ACCESSIBILITY ASSESSMENT

DATE OF REPORT:
March 4, 2025

ADA TITLE II ASSESSMENT

Guy Lee Elementary School
755 W Harlow Road
Springfield, Oregon 97477

Map for Barrier ID: AX545145

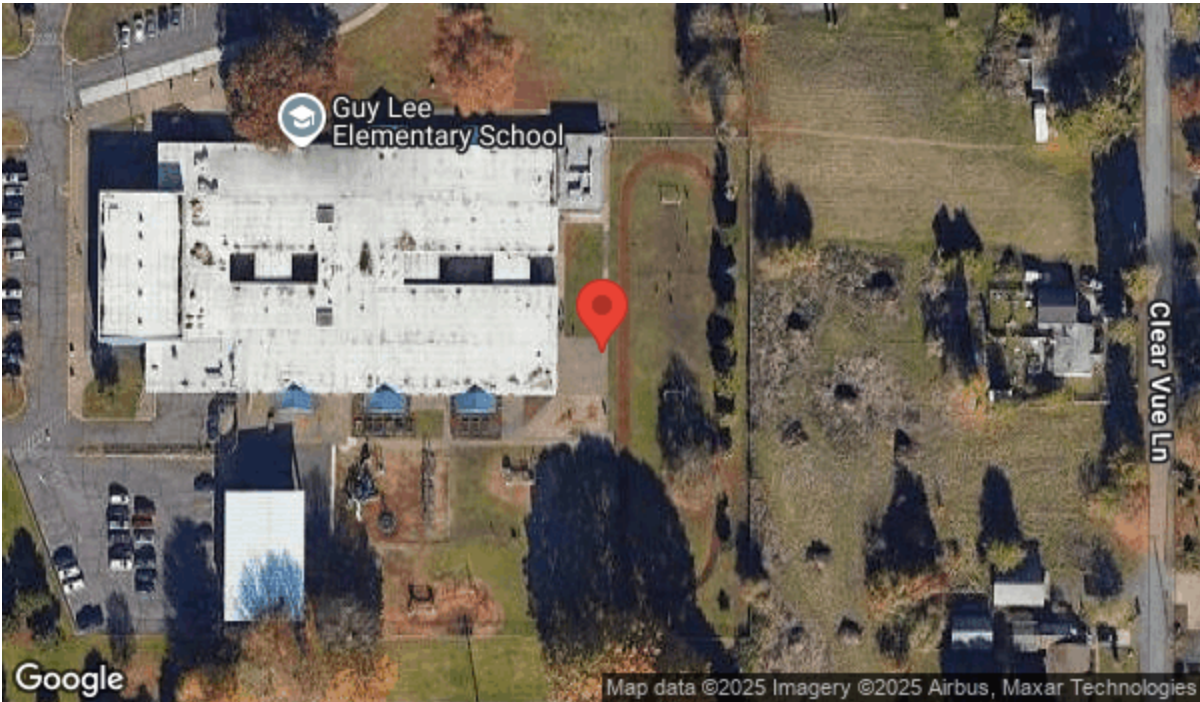
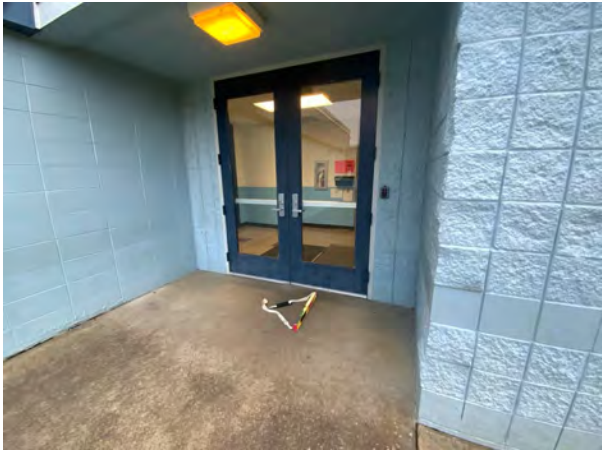
Assembly	Entrance to Building
Type	Building Entrance - Door
ADA Standard	305.2; 404.2
Barrier Detail	The maneuvering clearance at the accessible door is not level and clear.
Location Description	East Doors
Observed	Jan 6, 2025 by Danjo.Ginete@bureauveritas.com
Site Conditions	The maneuvering clearance at the door has a slope of 2.6% - 3.2%.

Remove and replace the surface within the required maneuvering clearance area so that the surface is level and clear with maximum slope 1:48 (2.08%) in any direction. The required depth of the maneuvering clearance is X" minimum. The required side clearance is Y" minimum on the latch/hinge side of the door. Maneuvering clearance shall extend the full width of the doorway and the required latch side or hinge side clearance. Floor or ground space within the required maneuvering clearance shall be maximum 1:48 (2.08%) slope. Changes in level are not permitted.

Photos for Barrier ID: AX545171

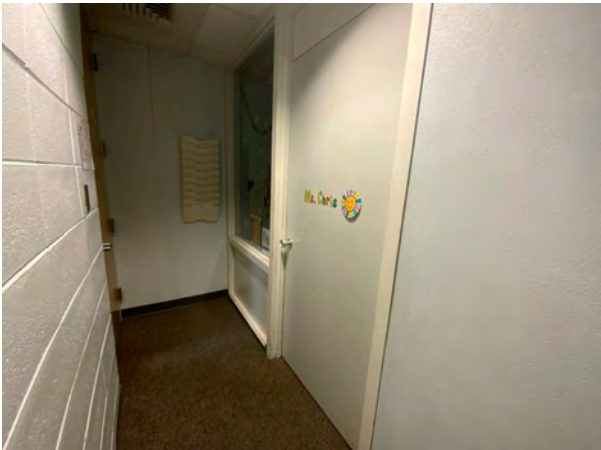
Assembly	Interior Access Route
Type	Door
ADA Standard	404.2.4; Table 404.2.4.1
Barrier Detail	
The push side of the accessible door does not have the required maneuvering clearances.	
Location Description	Health Office
Observed	Jan 6, 2025 by Danjo.Ginete@bureauveritas.com
Site Conditions	For a hinge approach on the push side, the maneuvering clearance is 40 1/2"
Width	40 1/2"

Redesign to provide the required maneuvering clearance on the push side the door. The required depth of the maneuvering clearance is 42" minimum. The required side clearance is 22" minimum on the hinge side of the door. Maneuvering clearance shall extend the full width of the doorway and the required latch side or hinge side clearance. Floor or ground space within the required maneuvering clearance shall be maximum 1:48 (2.08%) slope. Changes in level are not permitted.
